IFS Texwear (PVT) Ltd. 5S Composite Ltd.

PLOT NO. 631, KUTUBPUR, FATULLAH, NARAYANGANJ, BANGLADESH
(23.647089N, 90.500948E)
29 APRIL 2014

Cracking in corner column

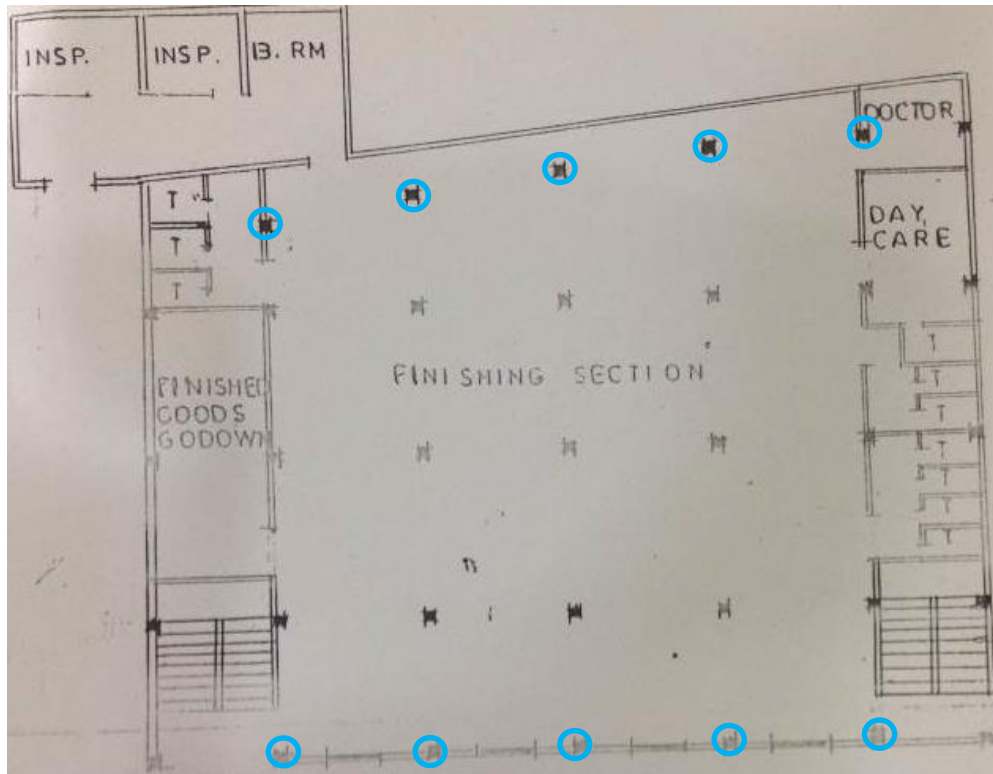
Cracking and damage to corner column

- Significant cracking and damage identified in corner column at three levels shown.
- Crack was opened up at fourth floor level confirming that it extended into the column.
- Similar cracking was observed at second floor level.
- At ground level damage was identified.

The corner column needs additional temporary support installed and removal of water tank loading.

Item No.	Observation	Recommended Action Plan	Recommended Timeline
1	Cracking in corner column	Drain water from tanks over stairwell to reduce load carried by columns.	Immediate - Now
2	Cracking in corner column	A Detail Engineering Assessment on the 5-storey building to be commenced immediately, see attached scope.	Immediate - Now
3	Cracking in corner column	If necessary, replace column while providing temporary support to the slabs. Any temporary propping to be designed by Building Engineer.	6-weeks
4	Cracking in corner column	Detail Engineering Assessment to be completed	6-weeks
5	Cracking in corner column	Implement actions arising from Detail Engineering Assessment, including possible strengthening or replacement of column as required.	6-months
6	Highly-stressed columns at front and rear elevations Verify concrete strengths in columns for all 400 x 280 columns (front and rear facades)	Factory Engineer to review design, loads and column stresses supporting cantilevers at front and rear facades.	Immediate - Now

Discrepancies between documentation and as-built structure

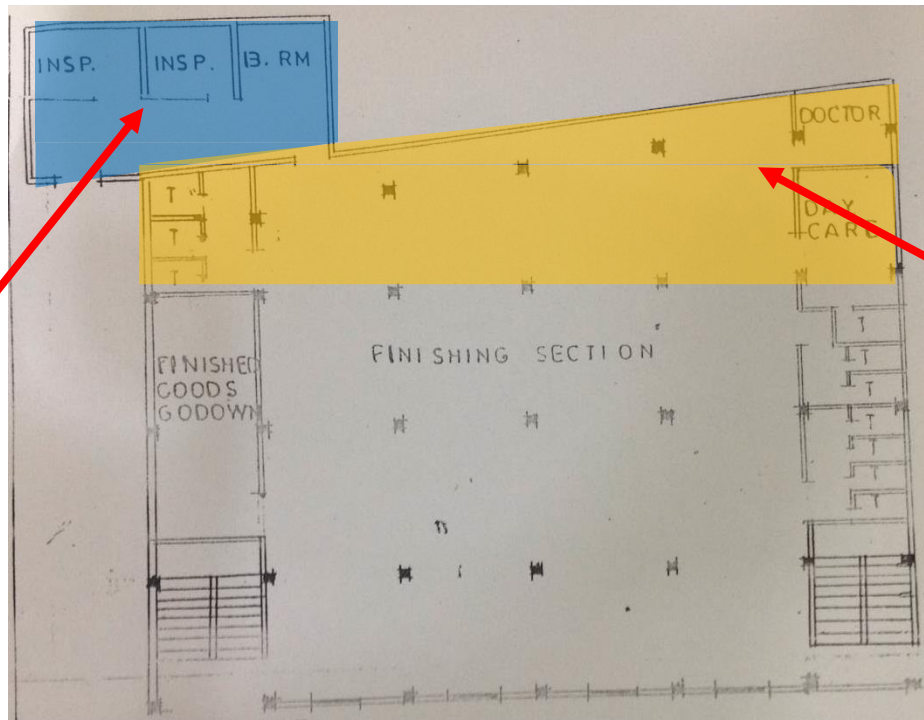
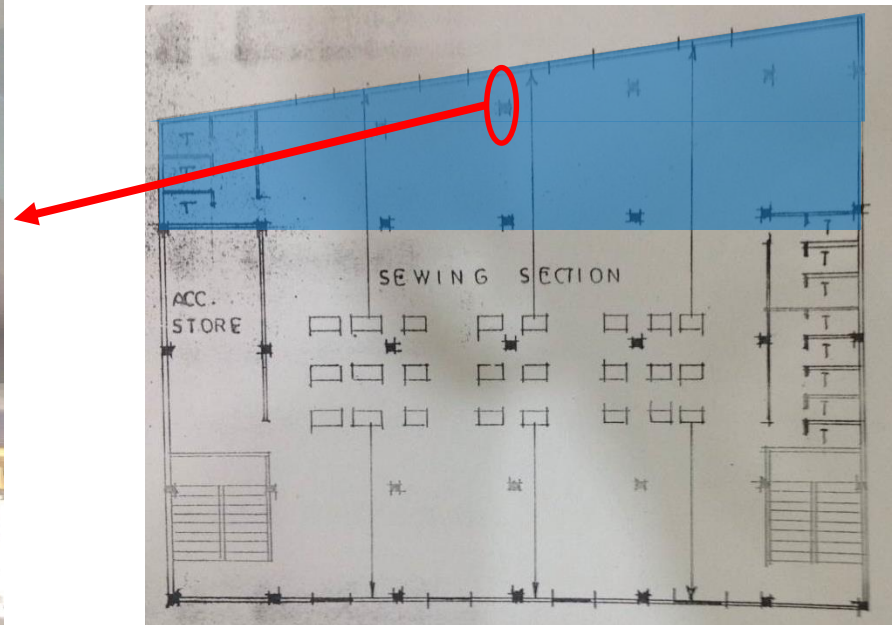
On ground floor only – not shown on structural drawings

Full height of building – not shown on structural drawings

- An additional bay extending out the back of the building was constructed over the entire height of the building.
- There was also an extension constructed to the back at ground level only.
- Both these items were present on the layout drawings but not on the structural drawings.
- It was also observed that grid layout, beam and column sizes on the structural drawings did not match with what had been constructed.

Item No.	Observation	Recommended Action Plan	Recommended Timeline
13	Discrepancies between documentation and as-built structure	As part of Detail Engineering Assessment (see Item 1), ensure structural as-built drawings are produced for the building extent.	6-weeks
14	Discrepancies between documentation and as-built structure	Design calculations for the building should be undertaken, with a proposed load plan produced.	6-weeks
15	Discrepancies between documentation and as-built structure	Continue to implement load plan.	6-months
15	Beam & column cracking in undocumented area	As part of Detail Engineering Assessment (see Item 1), check capacity of the cantilever beams and the supporting columns.	6-weeks
15	Beam & column cracking in undocumented area	Implement actions arising from Detail Engineering Assessment.	6-months
15	Cracking in beams & slabs at all levels	As part of Detail Engineering Assessment (see Item 1), investigate if cracks penetrate the building structure.	6-weeks

Cracking in beams & slabs at all levels

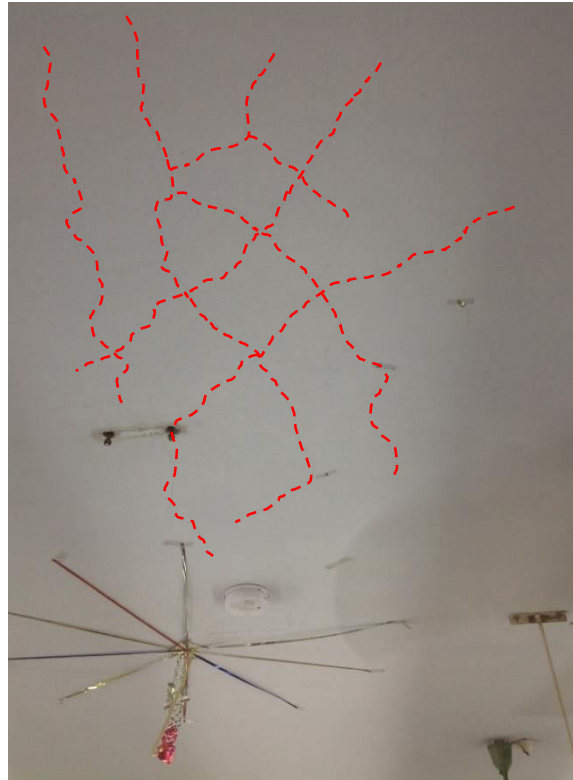
Beam cracking

Slab cracking

Cracks were observed in the beams and slabs on all floor levels.

- They occurred on each side of the beam throughout its length. In many locations these cracks extended through the soffit and up both sides of the beam.
- Cracks in the soffit of the floor slab were typically observed in and around the centre of the span. These were particularly visible on the soffit of the second floor.

15	Cracking in beams & slabs at all levels	Implement actions arising from Detail Engineering Assessment, including any concrete repairs or strengthening required to beams or slabs.	6-months

Cracking in walls throughout both stairwells

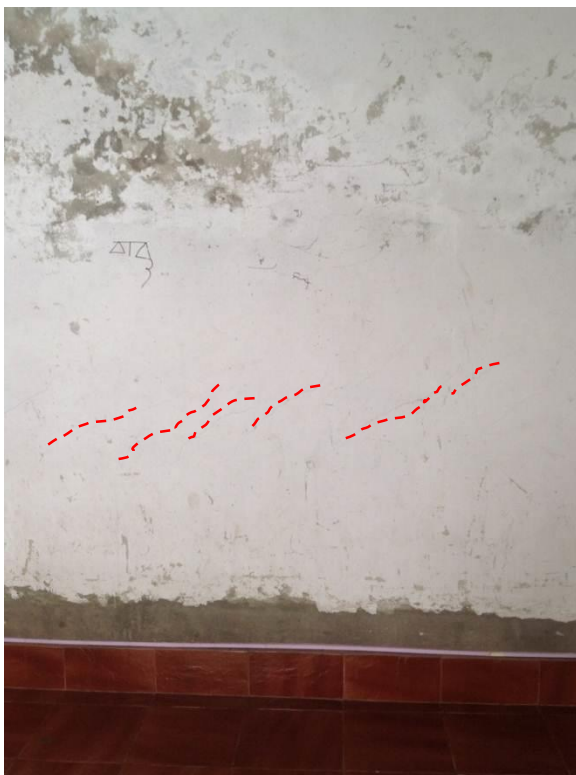
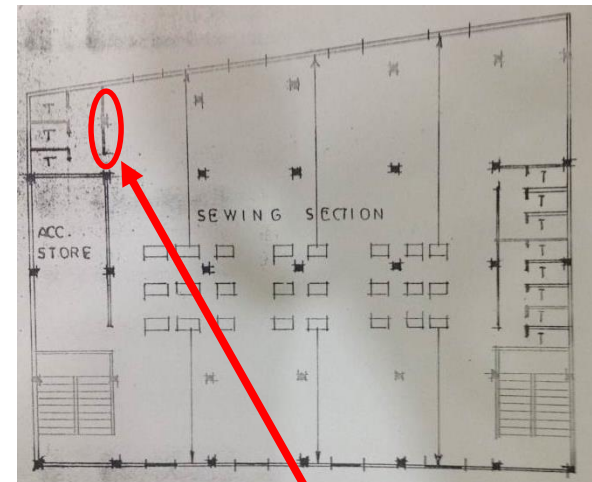
Stairwell side

Workshop side

Cracks were observed in the walls at most levels in both stairwells of the building.

- These cracks were predominately diagonal and extended through the wall to both faces.
- A possible reason for these cracks is due to significant deflection on the inner beam of the stairwell compared with the outer beam. However, this could not be confirmed from visual inspection.

Item No.	Observation	Recommended Action Plan	Recommended Timeline
15	Cracking in walls throughout both stairwells	As part of Detail Engineering Assessment (see Item 1), Identify the cause(s) of the cracking.	6-weeks
15	Cracking in walls throughout both stairwells	Rectify the cause(s) of the cracking.	6-months
15	Cracking in walls throughout both stairwells	Repair cracks as recommended by the Detail Engineering Assessment	6-months
15	Non-engineered metal roof structure	Stability system in metal roof to be checked as part of Detail Engineering Assessment (see Item 1).	6-weeks
15	Non-engineered metal roof structure	The structural behaviour in the area highlighted above is to be checked, including perimeter wall supporting the column.	6-weeks
15	Non-engineered metal roof structure	Implement actions arising from Detail Engineering Assessment.	6-months
15	Cracking at cantilevers at front of building	As part of Detail Engineering Assessment (see Item 1), check the capacity of the cantilever slab to withstand the façade loads.	6-weeks

Cracking at cantilevers to front of building

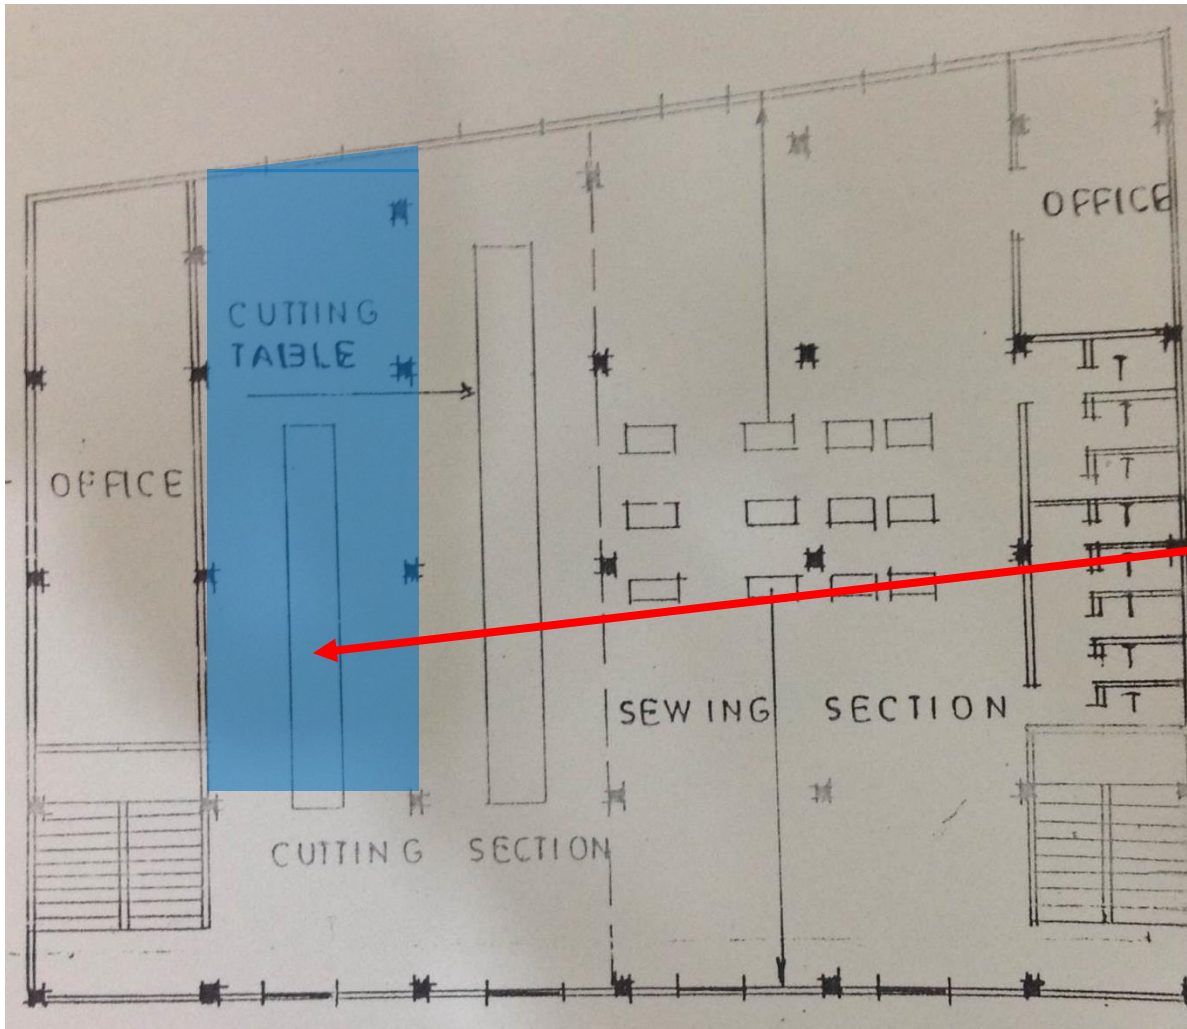
Horizontal cracking over windows

Vertical cracking at intersecting walls/floors

- Significant cracking evident in cantilever area on all upper levels at the front of the building.
- This appears to be due to deflection of the cantilever floors as a result of the parapet loads.

15	Cracking at cantilevers at front of building	Implement actions arising from Detail Engineering Assessment.	6-months

Misalignment between beams and columns

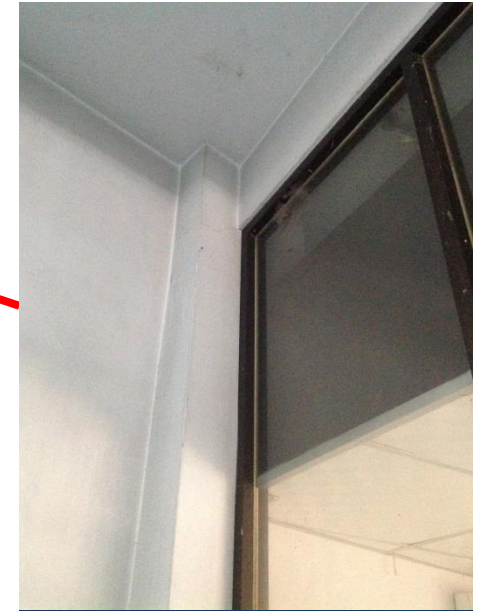
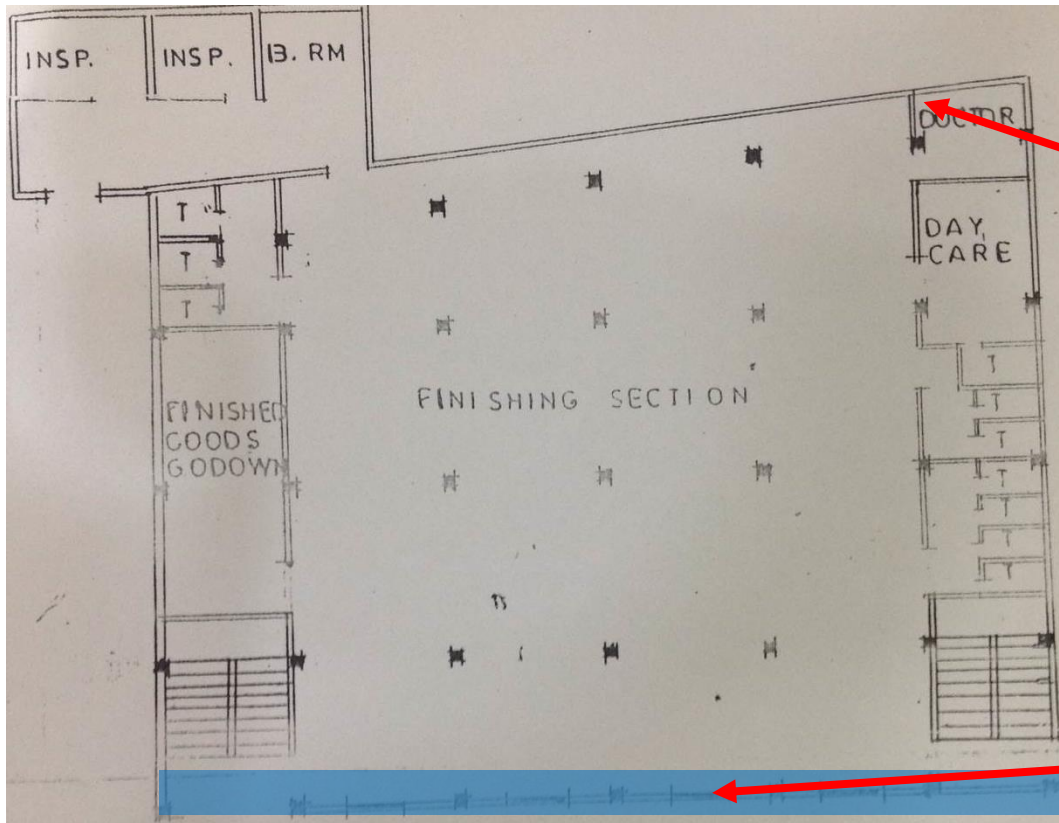
Column not centred
below beam

Beam along front face
of building in line with
outside face of column
